RHODE ISLAND CONTRACT NO.2017-CB-070

**Horton Farm Bridge No. 472**

**NOTICE TO PROSPECTIVE BIDDERS**

ADDENDUM NO. 5    Prospective bidders and all concerned are hereby notified of the following changes in the Plans, Specifications, Proposal and Distribution of Quantities for this contract. These changes shall be incorporated in the Plans, Specifications, Proposal and Distribution of Quantities, and shall become an integral part of the Contract Documents.

REVISIONS			RHODE ISLAND	
NO.	DATE	BY	DEPARTMENT OF TRANSPORTATION	
1	12/13/17	LBG	IMPROVEMENTS TO I-195	
			ABC BRIDGE NO. 472 OVER I-195	
			SUPERSTRUCTURE REPLACEMENT	
			EAST PROVIDENCE, RHODE ISLAND	
			BEARING DETAILS	
			SHEET 2 OF 3	
			CHECKED BY PNF DATE 9/22/17 SCALE AS NOTED

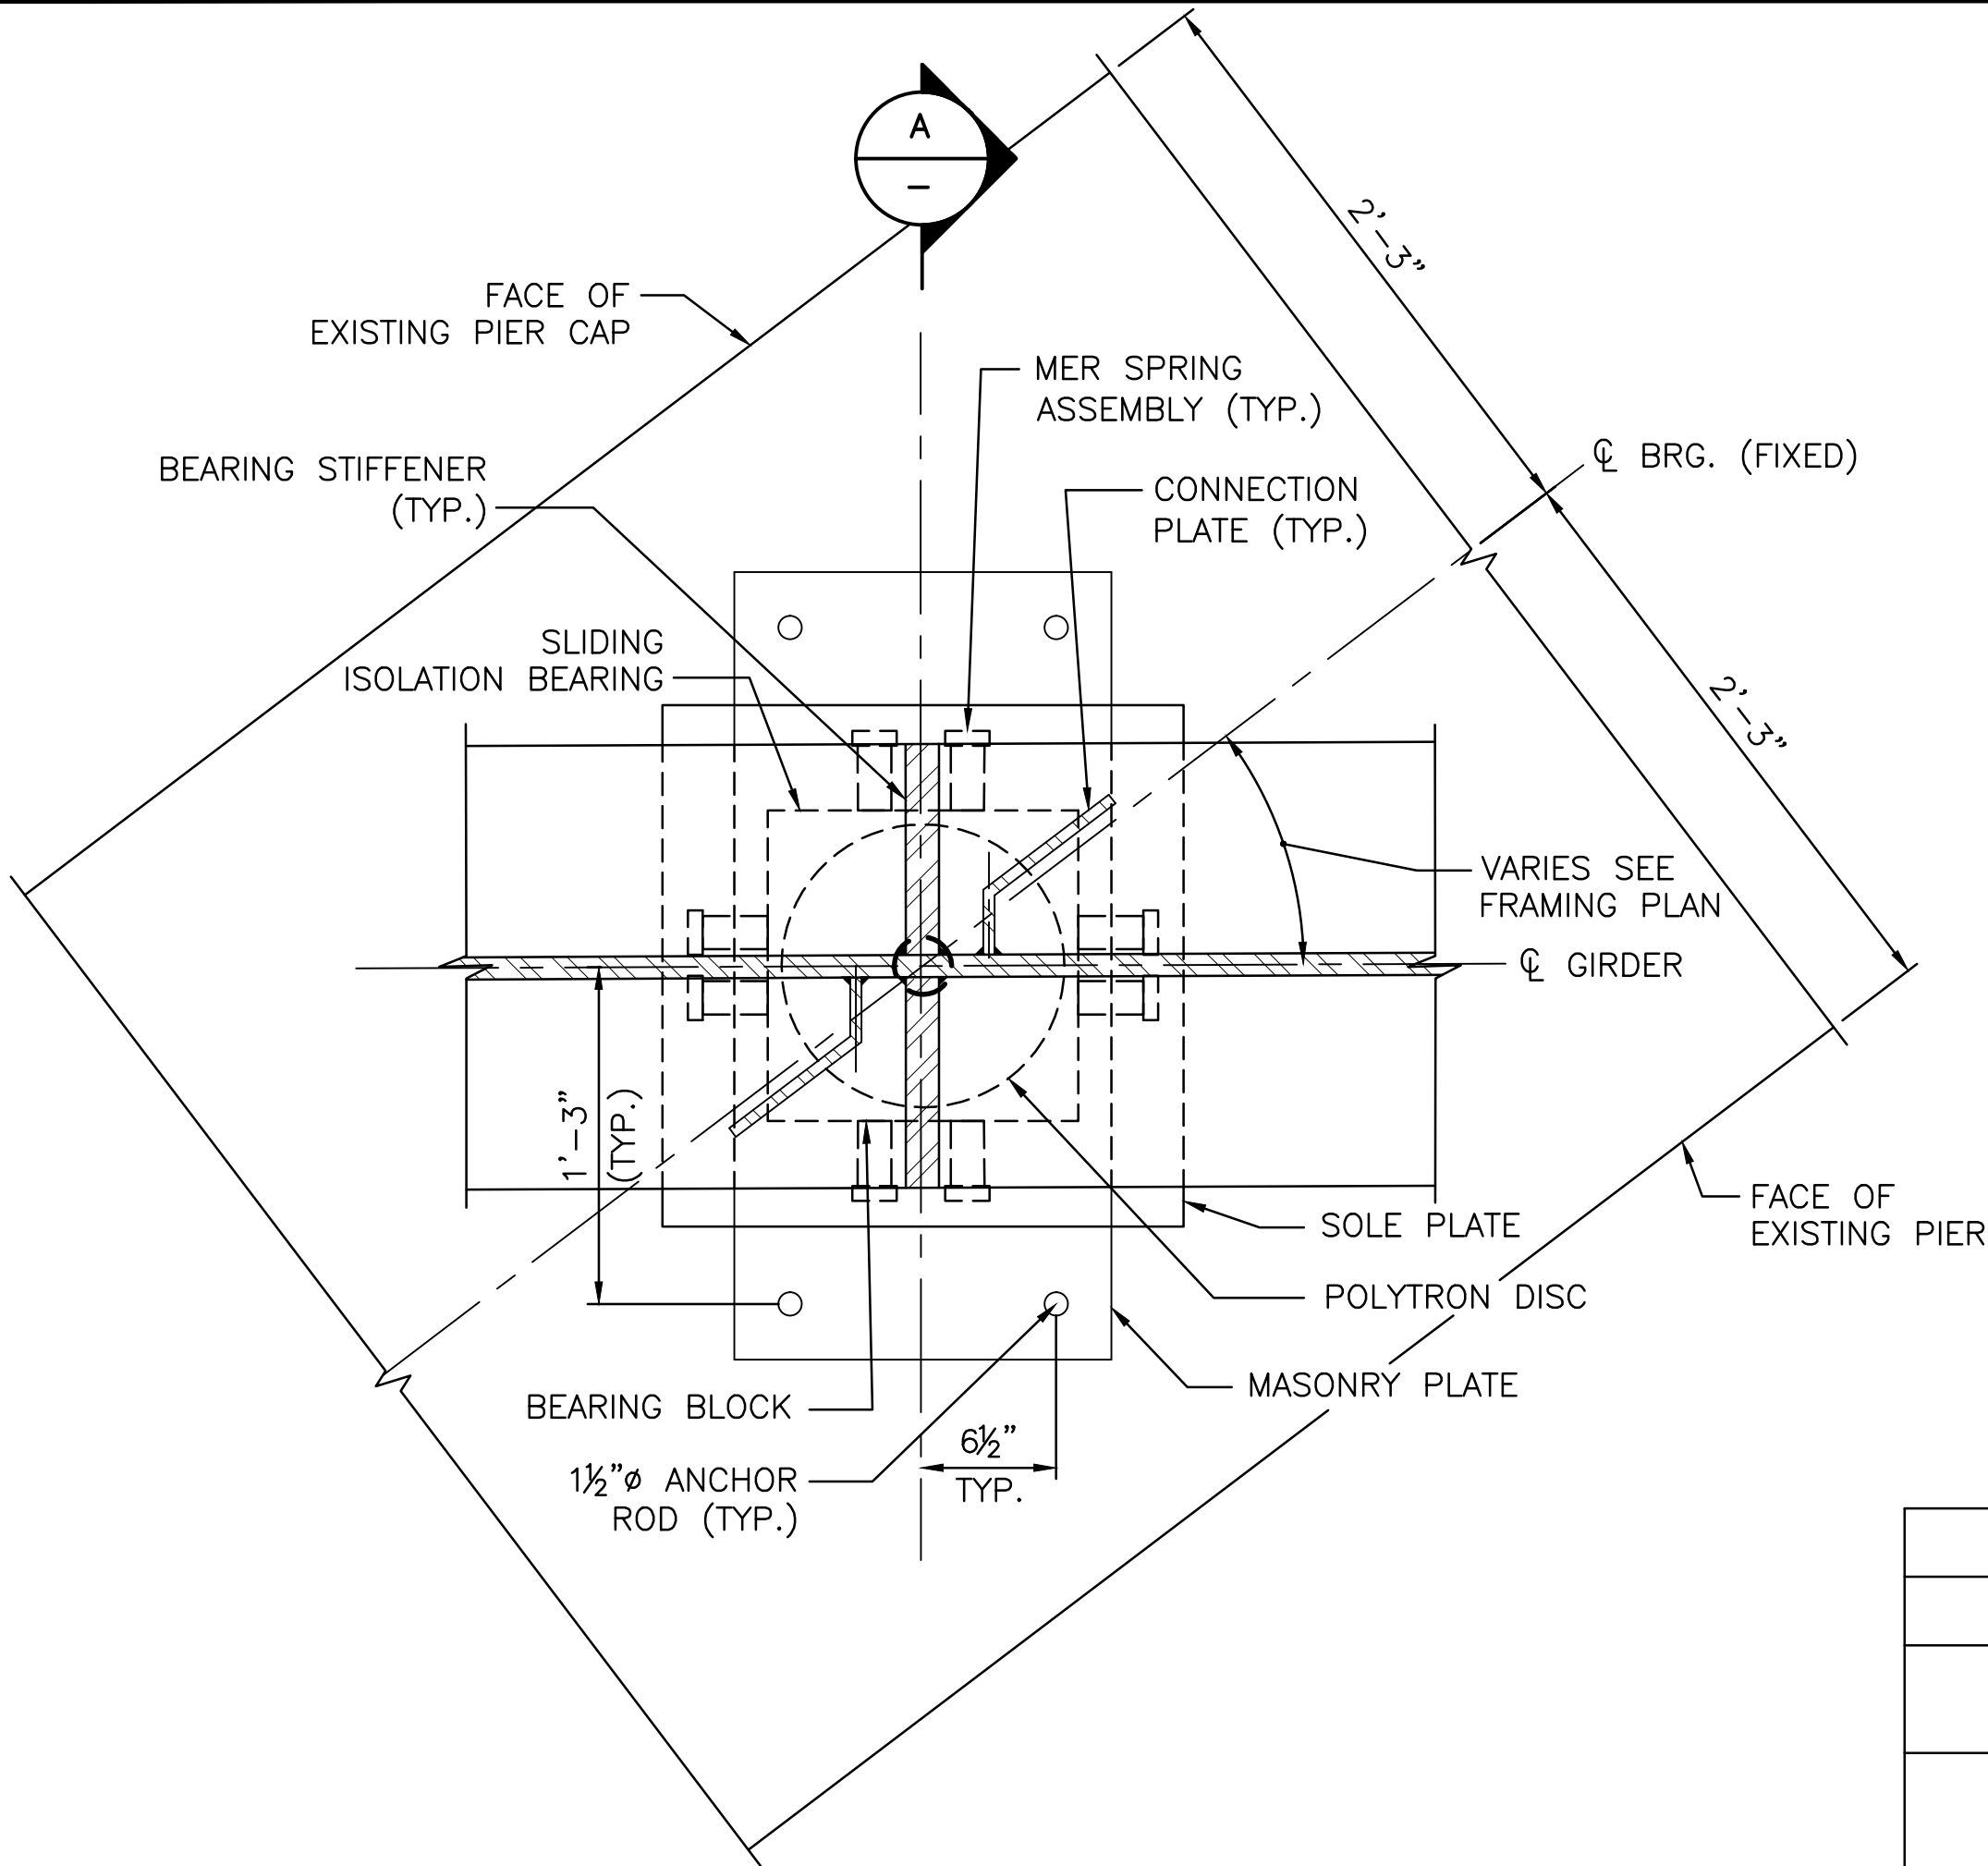
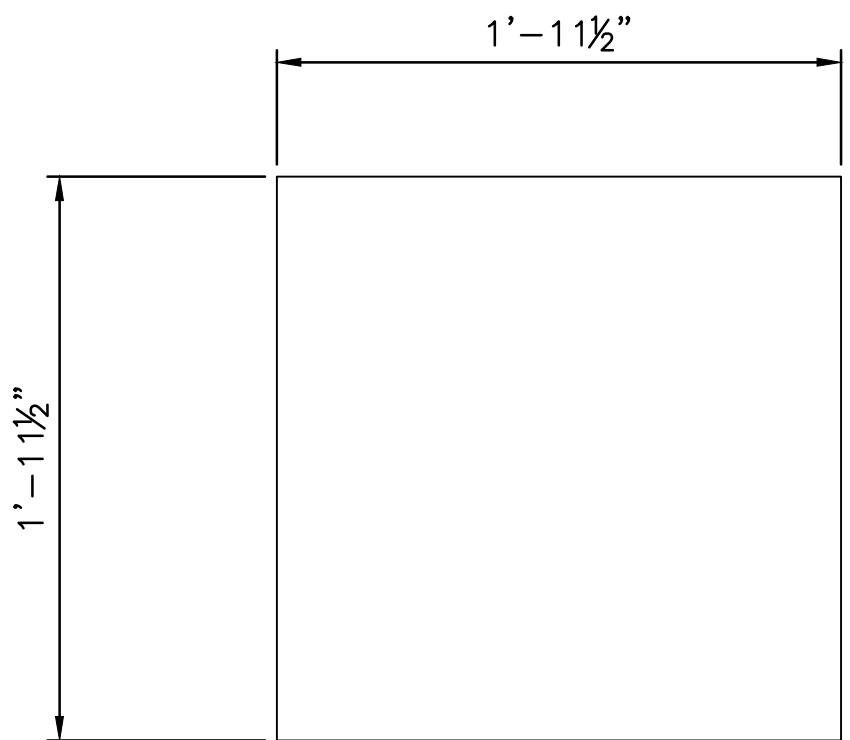
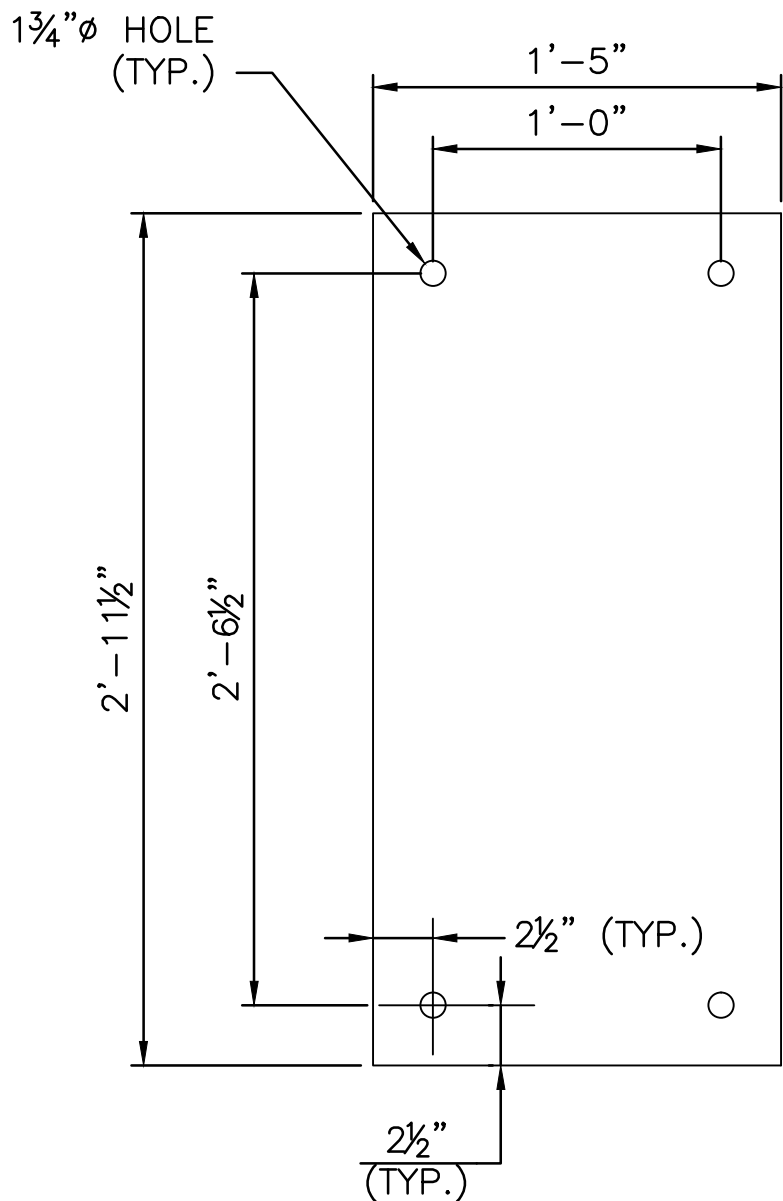
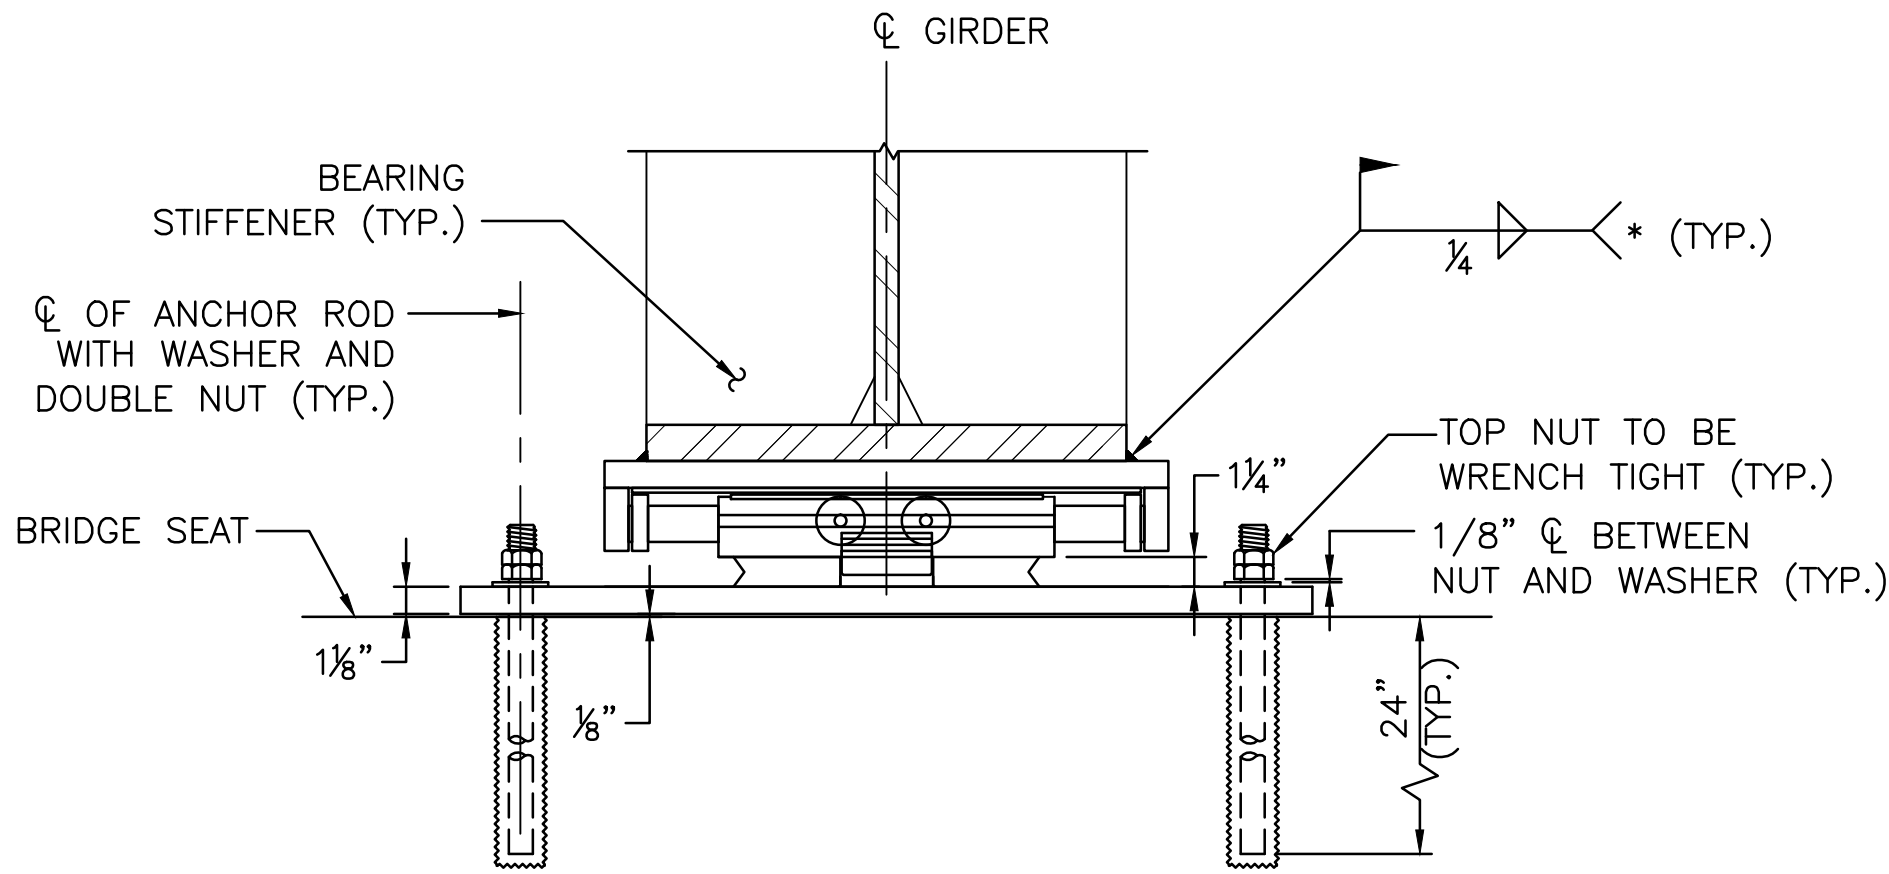
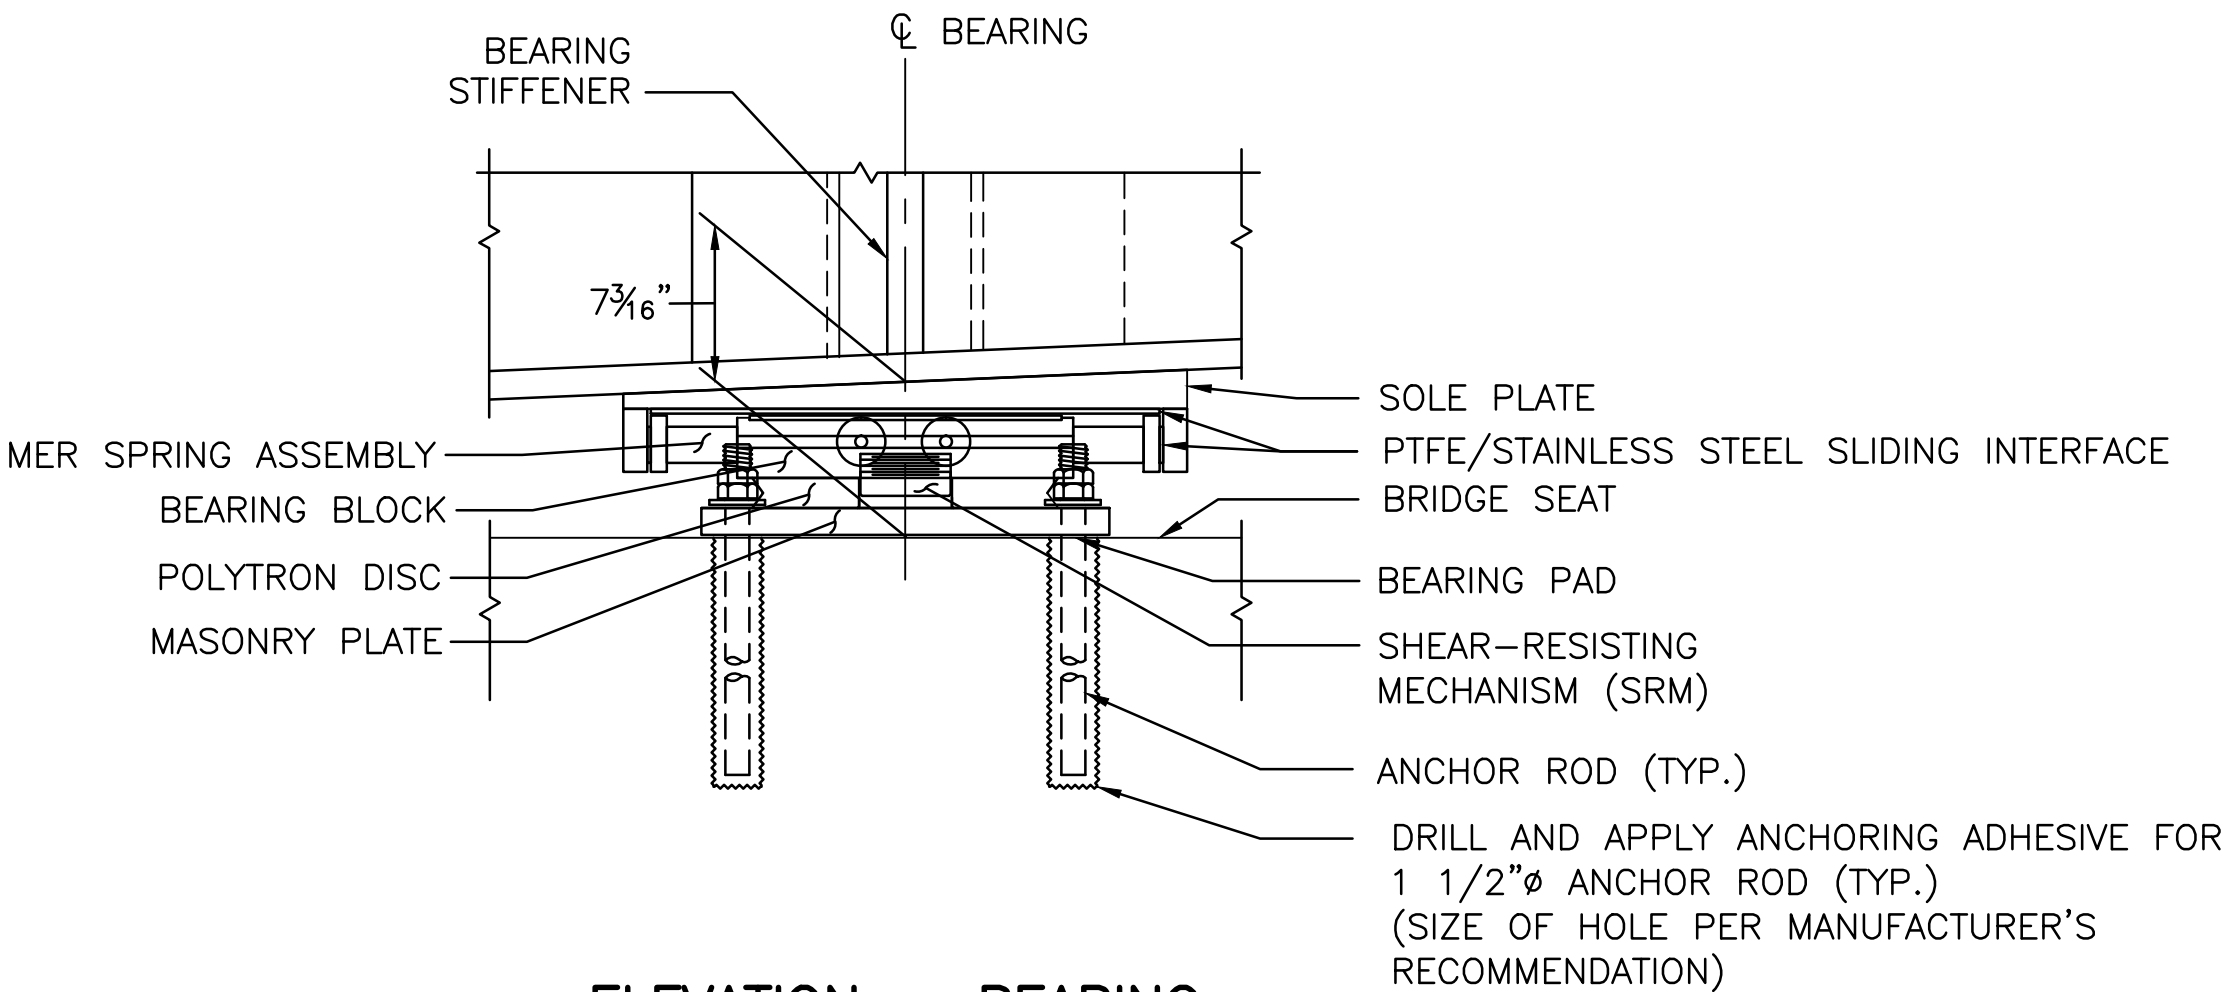
10. VOLUME 2 SHEET 45 - BEARING DETAILS SHEET 2 OF 3  
Remove and replace Sheet 45 in its entirety with Sheet 45(R-1) attached to this Addendum No. 5.  
This sheet has been revised.
